LEGEND AND PARTS LIST

MICHAEL L. HARTMAN HARTMAN ELECTRONICS INC. 8508 LIVINGSTON AVE. CHALMETTE, LA 70043	S.F.M.# D - 0000232 TECH.# E - 0001328 NICET # 081617
SCALE: 7/1/01	APPROVED BY: [Signature]
DATE: 7/1/01	DRAWN BY: [Signature]
FIRE ALARM SYSTEM GRAND LAGOON CONDOMINIUMS MARINA DR. - SLIDELL, LA	
	DRAWING NUMBER

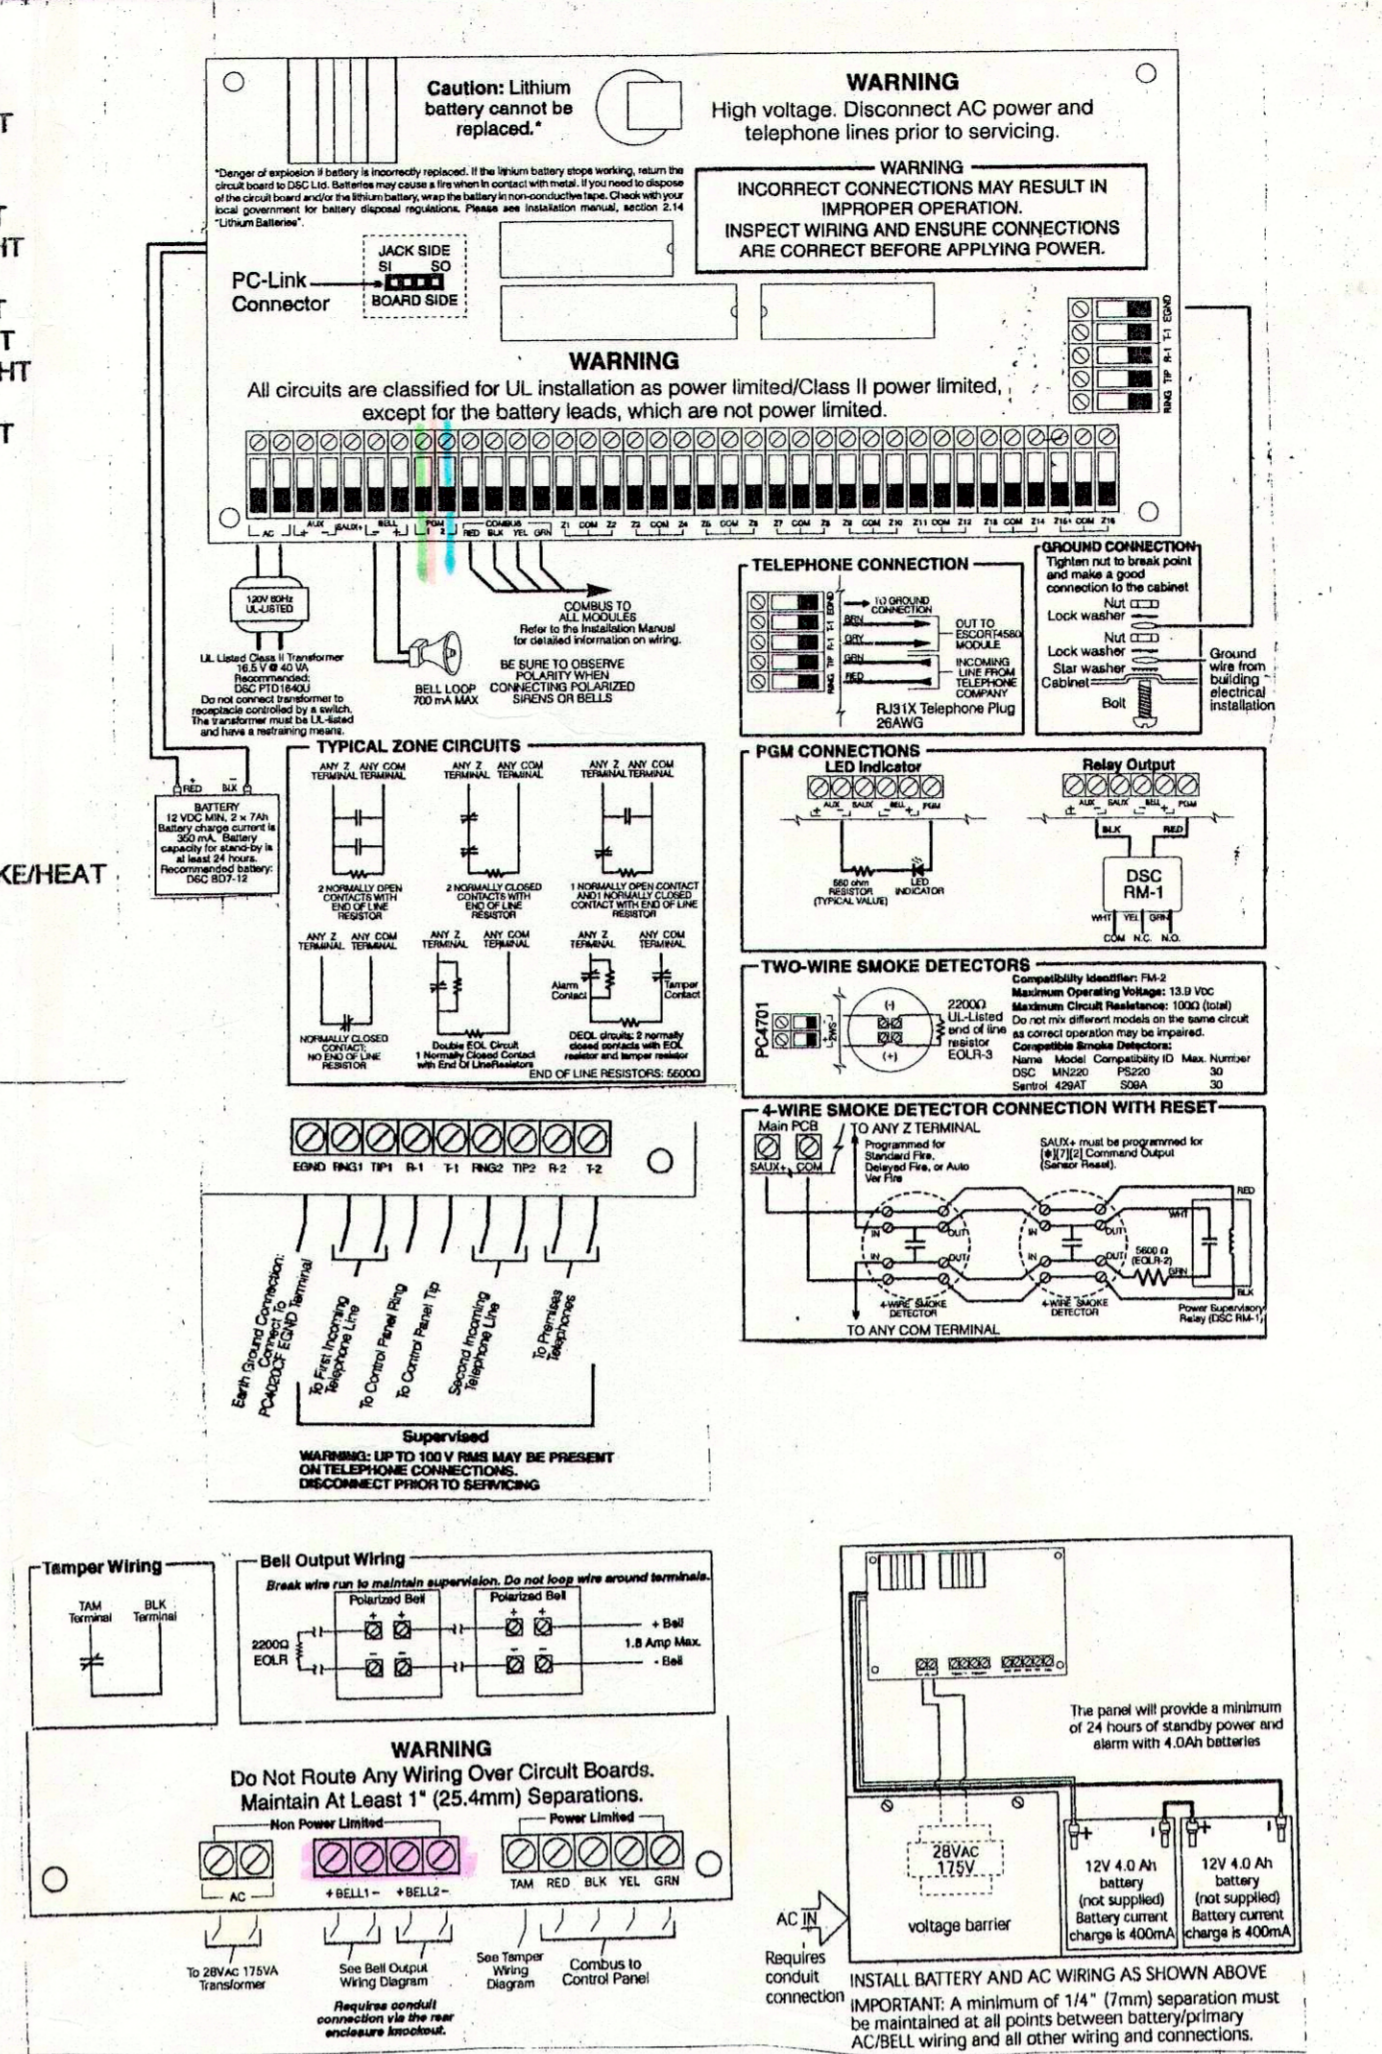
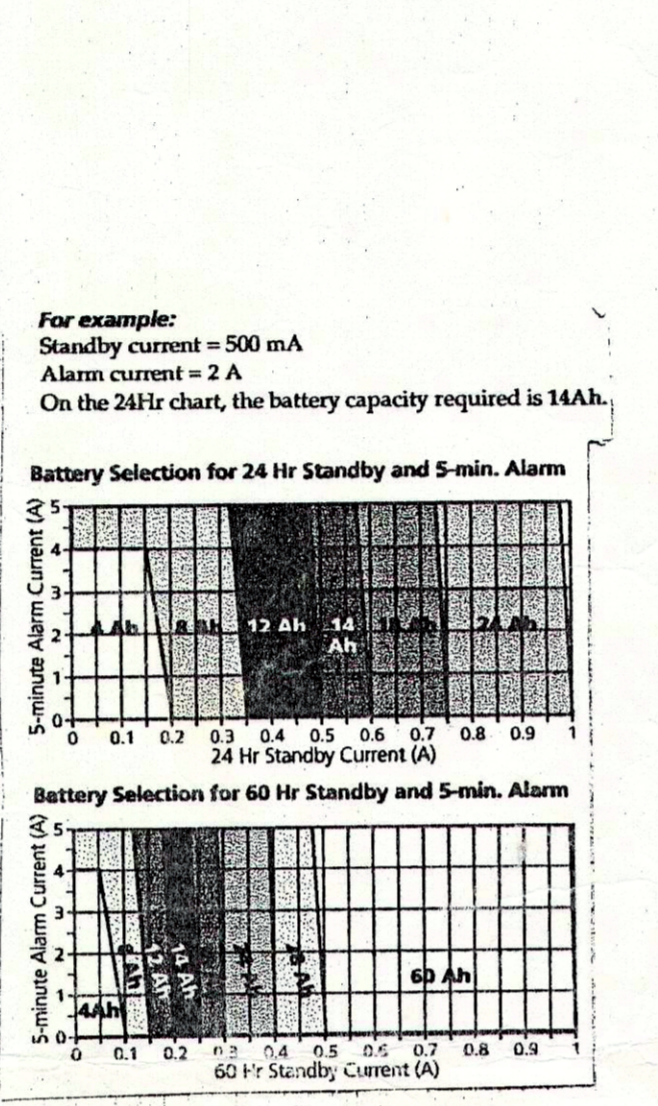
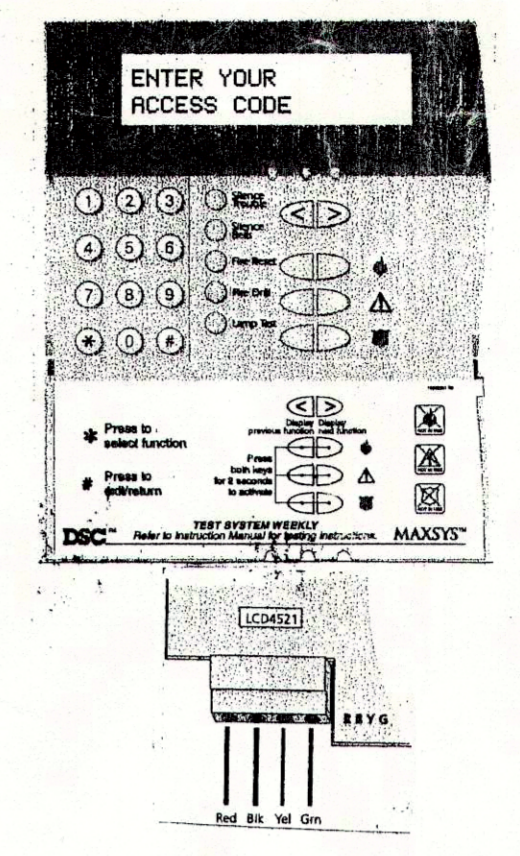
APPROVED AS NOTED BY [Signature]

Notes:
Prior to Installation
Vendor to coordinate installation
fall activities w/ Architect
Management Co.
8/29/01
